TO: Land Development Consultants
FROM: Julia Duncan, Associate Planner
DATE: May 19, 2022
SUBJECT: SP21-138; Auburn Hills Centre L4 - Circle K
Review Comments 01

CIRCLE K SITE DEVELOPMENT PLAN

PROJECT:
CIRCLE K STORES INC.
SITE DEVELOPMENT PLAN
MAINSTREET & JORDAN
TOWN OF PARKER, CO

SHEET TITLE:
COVER SHEET

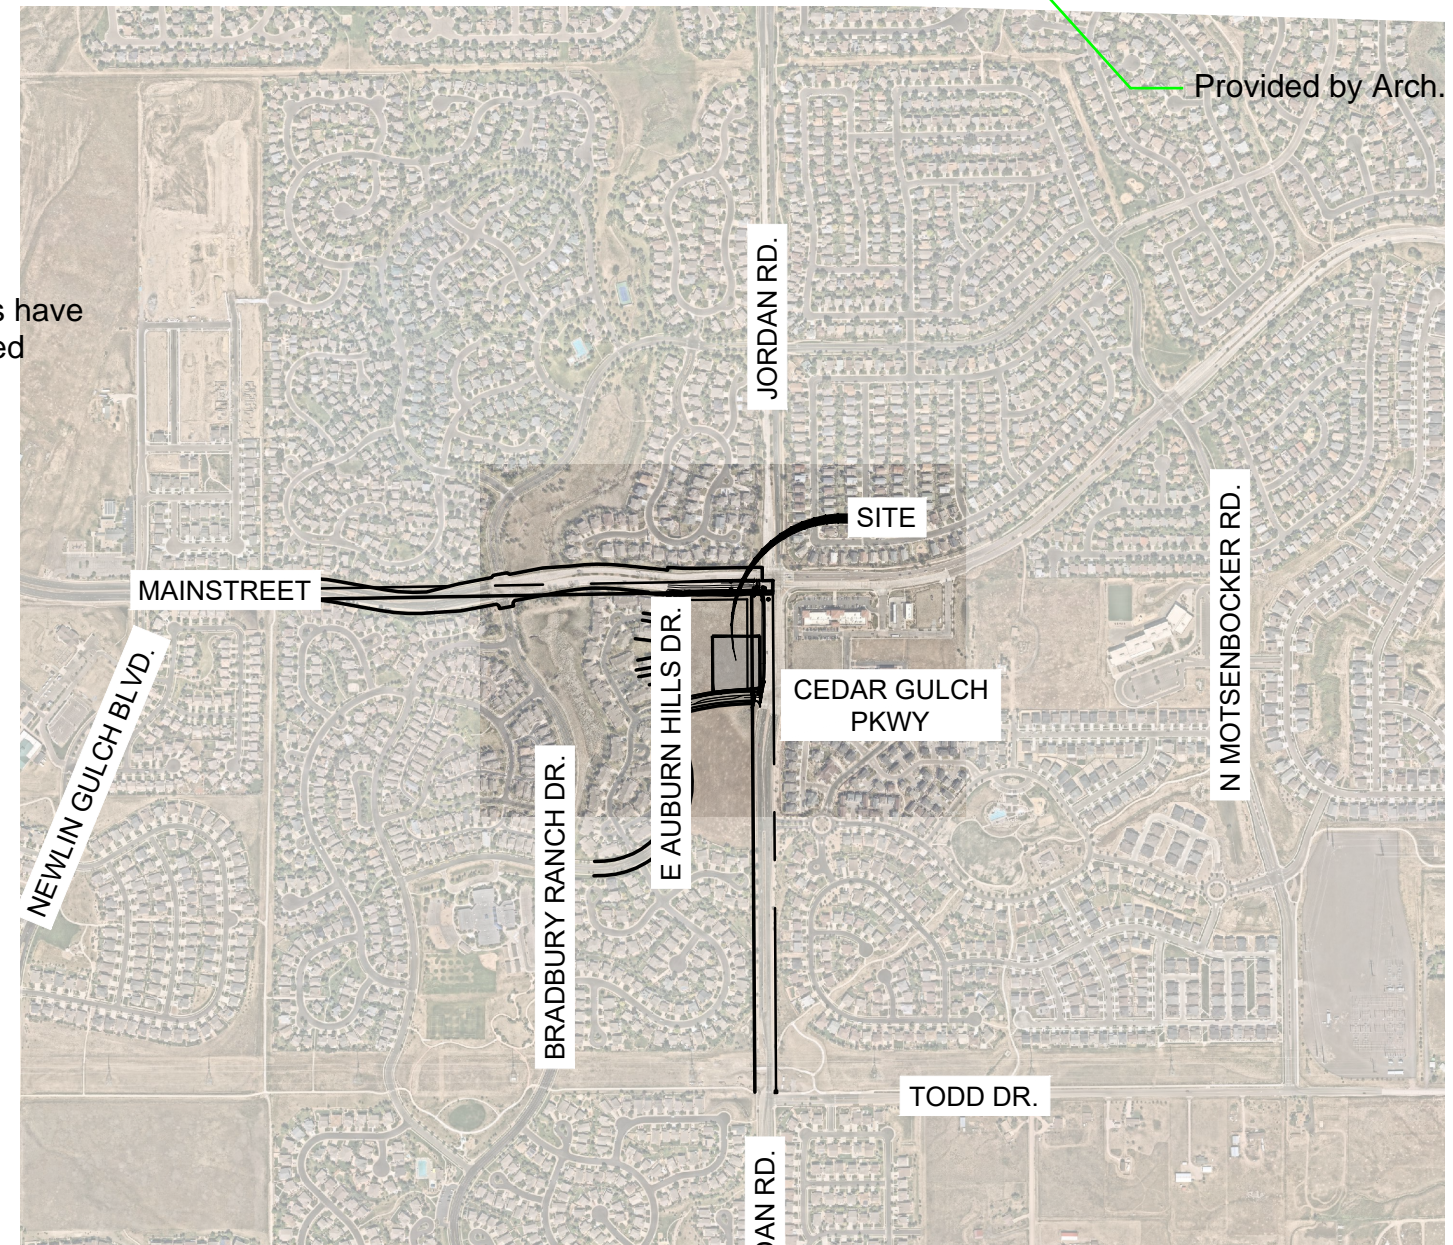
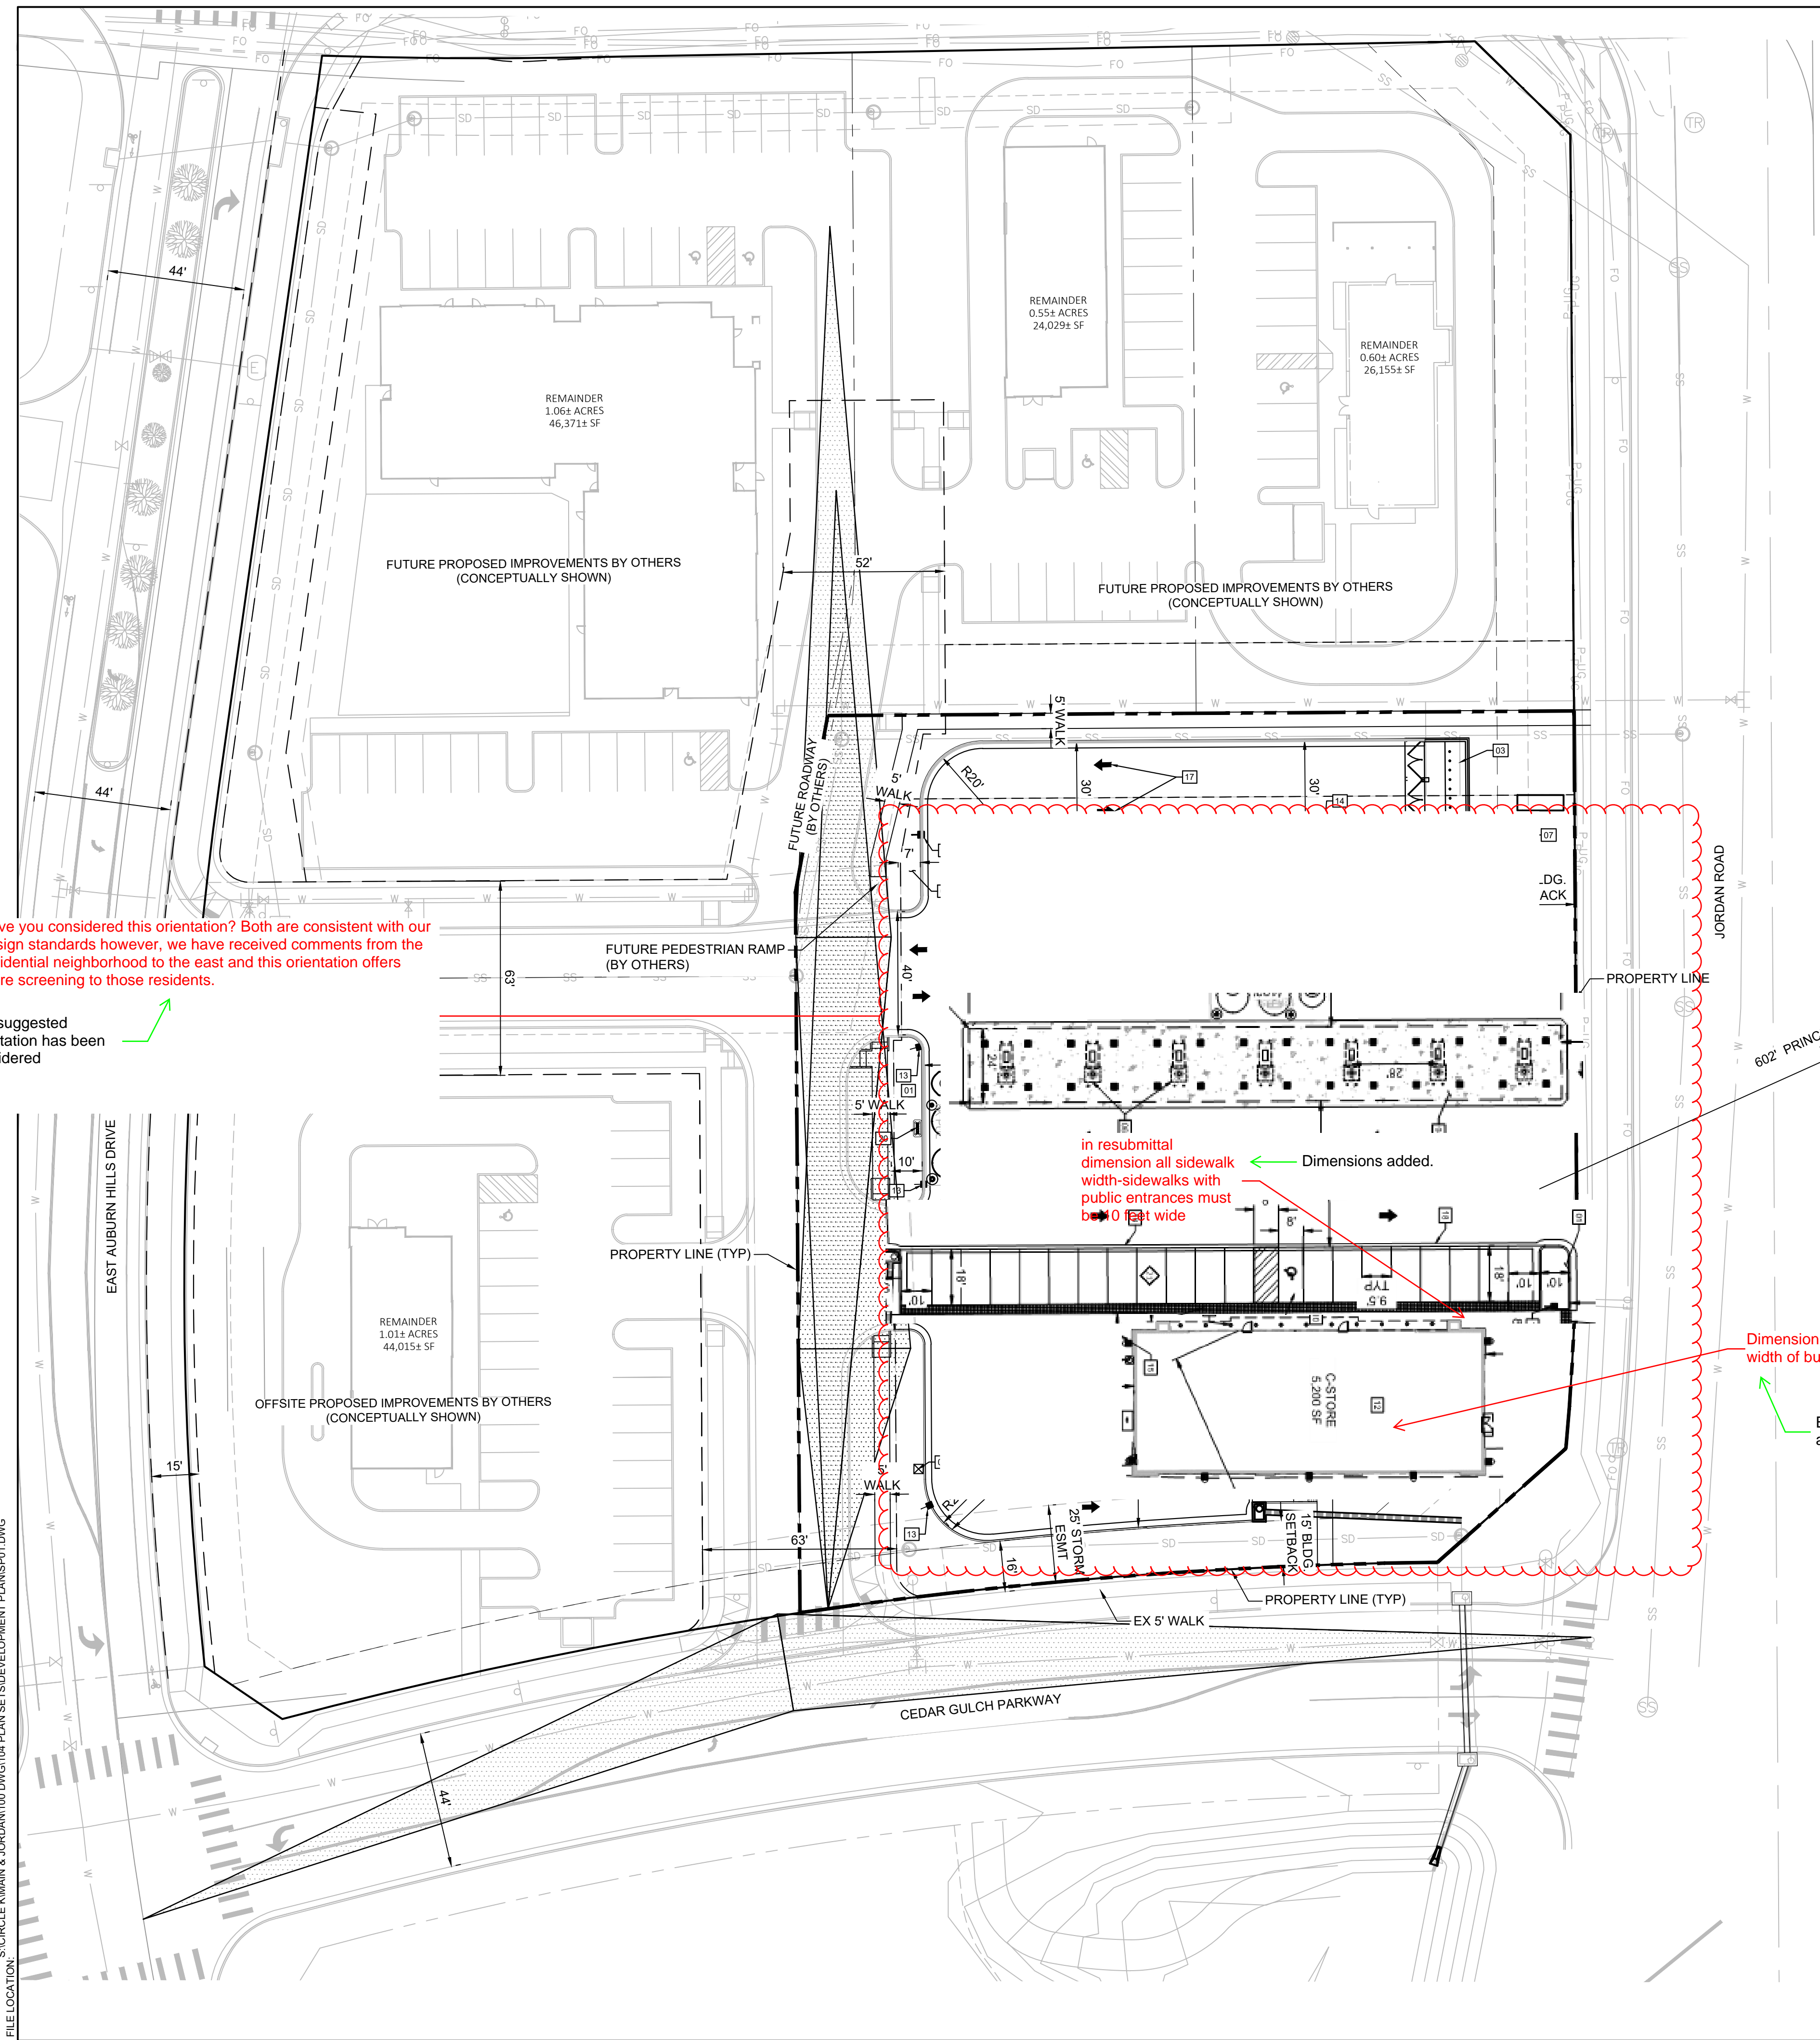
There are only four sheets-please include all sheets in one pdf, including elevations...etc.

This sum exceeds your gross lot area

Include ratio being used

Break all rows down like what you do in the below chart with Required/Maximums and Provided columns. I.e. required FAR and provided %

Max Coverage and provided...etc.

Where are these percentages coming from?
5763/69547=8.2%

in addition to delivering a physical materials board please include a sheet in the site plan for materials, screen shots or example I, etc.

Add required and provided yards. Along Jordan-25 feet. North, west, and east elevations are front yards. South is side yard. Cedar Gulch is side and has required 15 foot setback

SDP sheets will be combined for next submittal

Areas have been updated

percentages have been updated

Site information updated

Provided by Arch.

Required and provided setback are now shown

LANDSCAPE PLAN

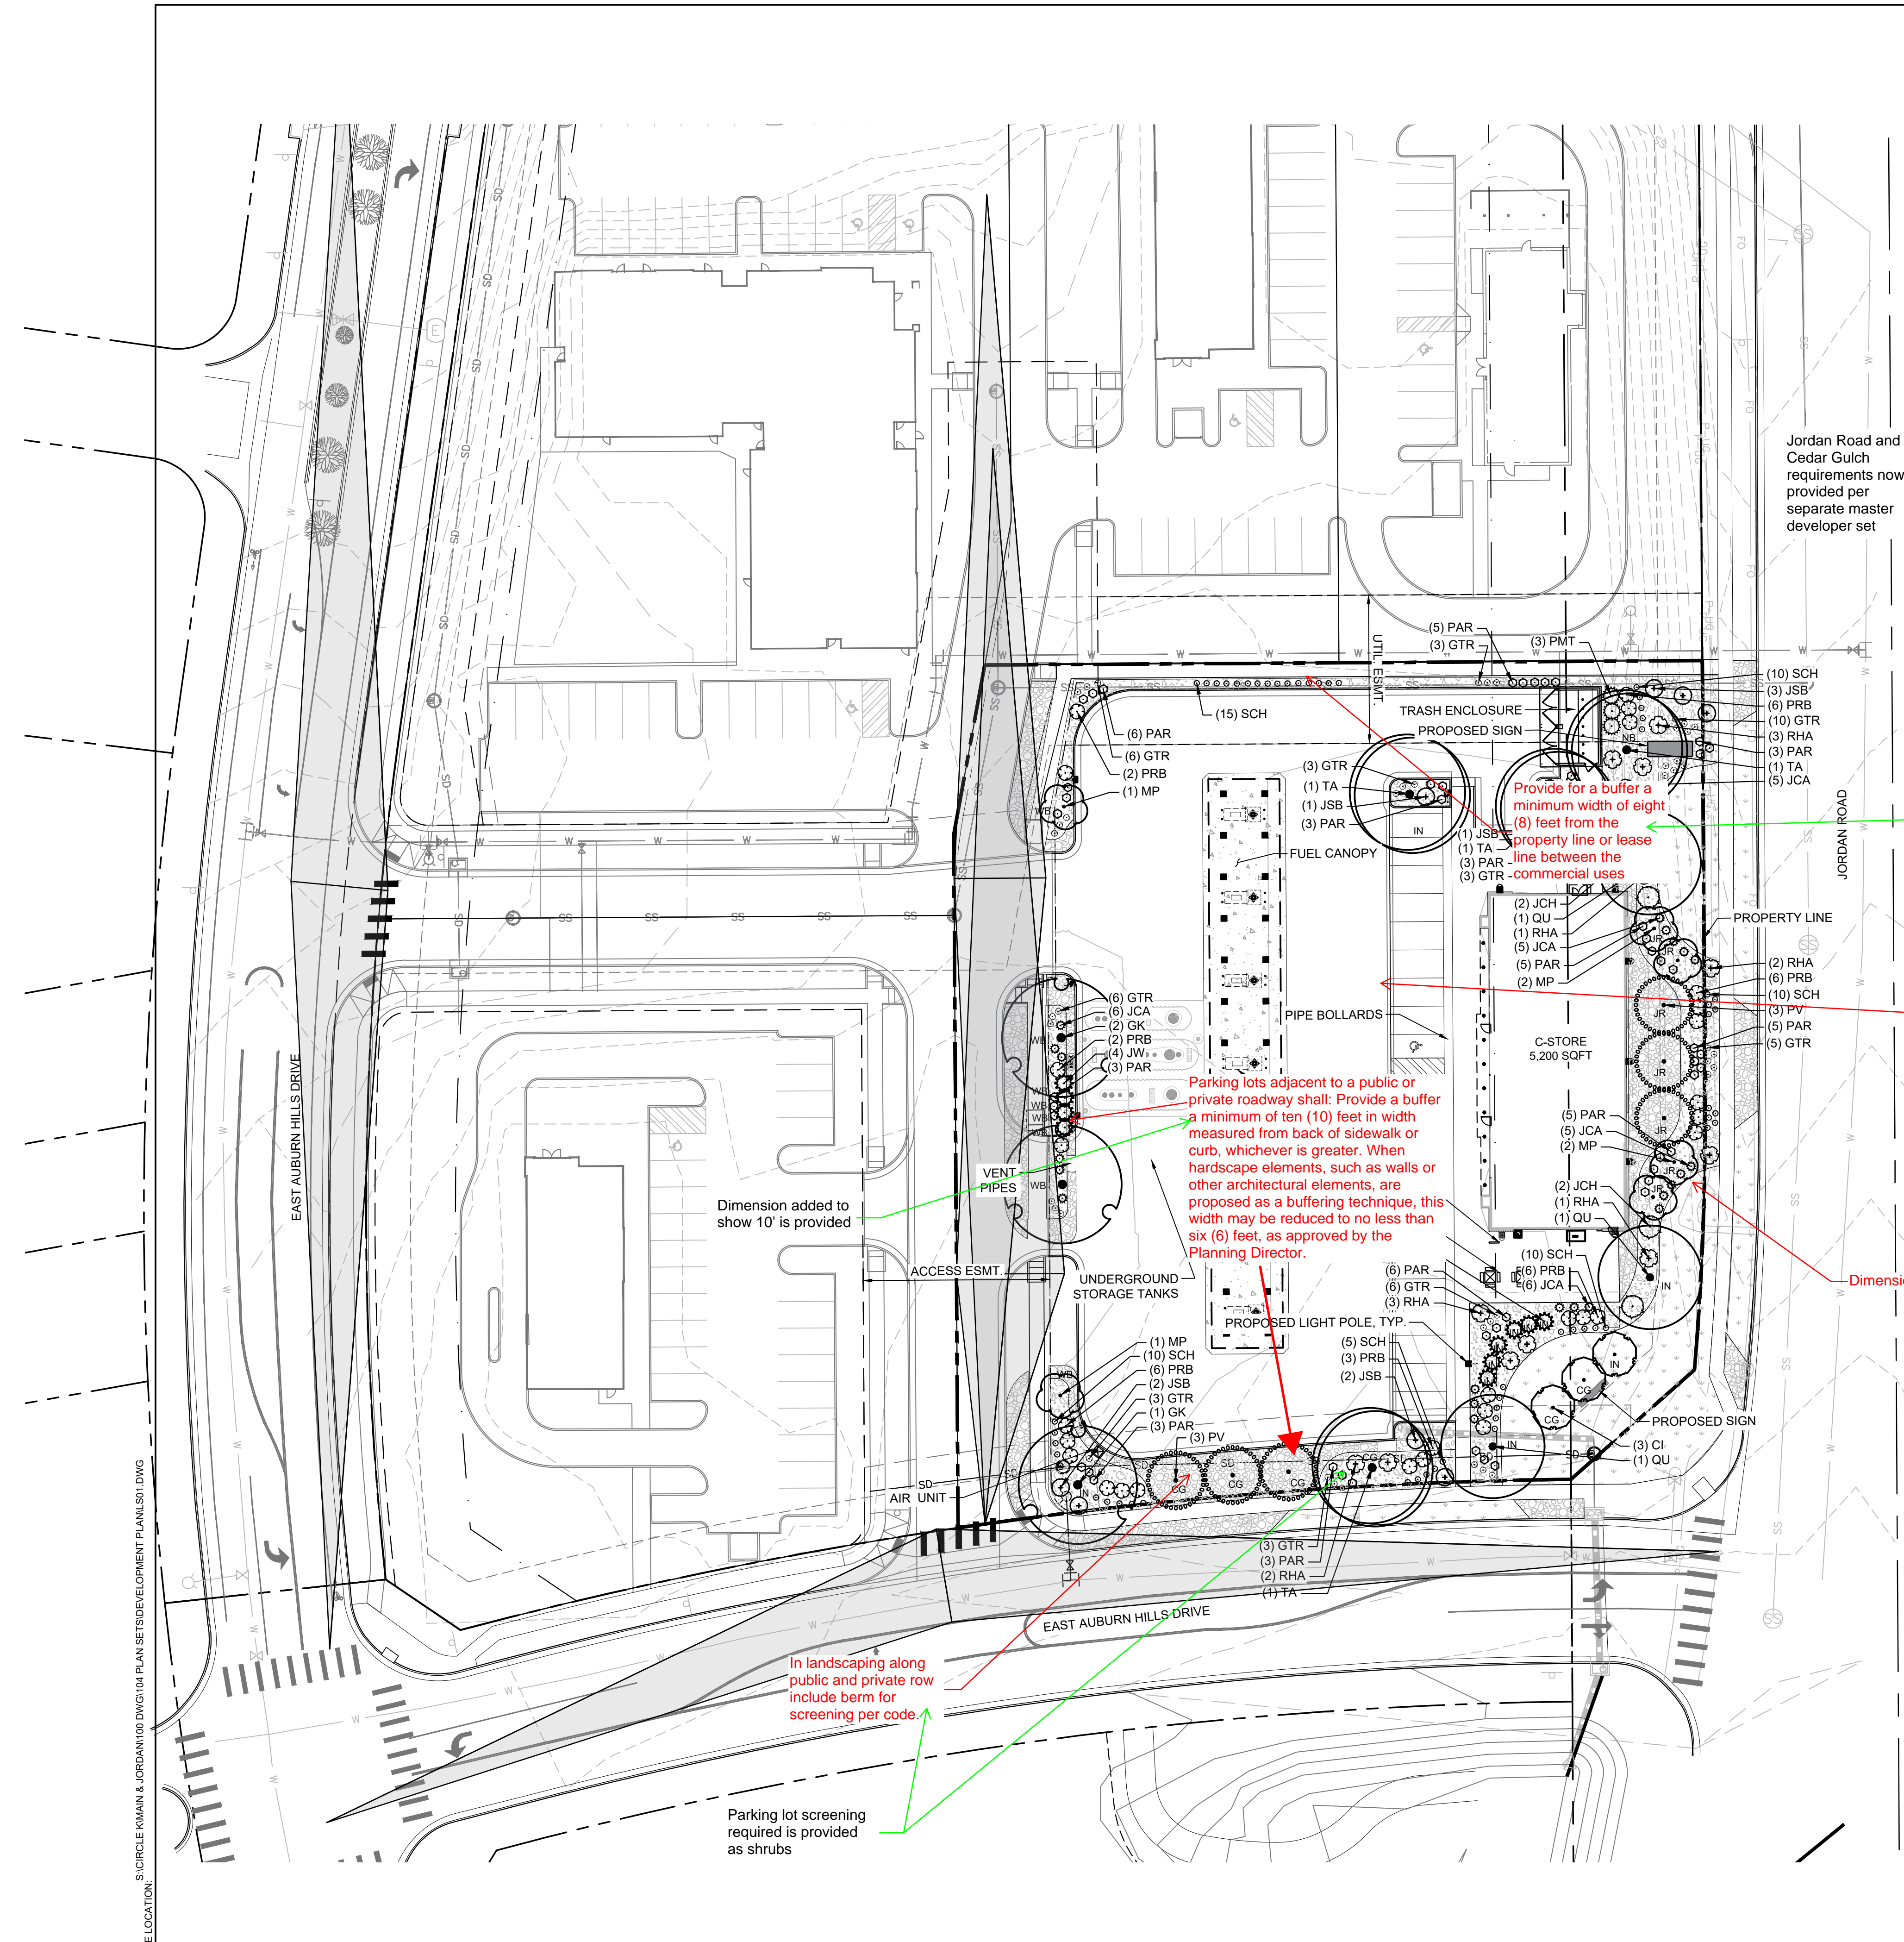
Cannot not provide-must make up elsewhere on site and meet 41 minimum

Cannot not provide-must make up elsewhere on site

Dimension this buffer

Provide for a buffer a minimum width of eight (8) feet from the property line or lease line between the -commercial uses

Parking lots adjacent to a public or private roadway shall: Provide a buffer a minimum of ten (10) feet in width measured from back of sidewalk or curb, whichever is greater. When hardscape elements, such as walls or other architectural elements, are proposed as a buffering technique, this width may be reduced to no less than six (6) feet, as approved by the Planning Director.

In landscaping along public and private row include berm for screening per code

Jordan Road and Cedar Gulch requirements now provided per separate master developer set

Site revised to provide 8' Dimension added to landscape plan

Dimension added

Dimension added to show 10' is provided

Parking lot screening required is provided as shrubs
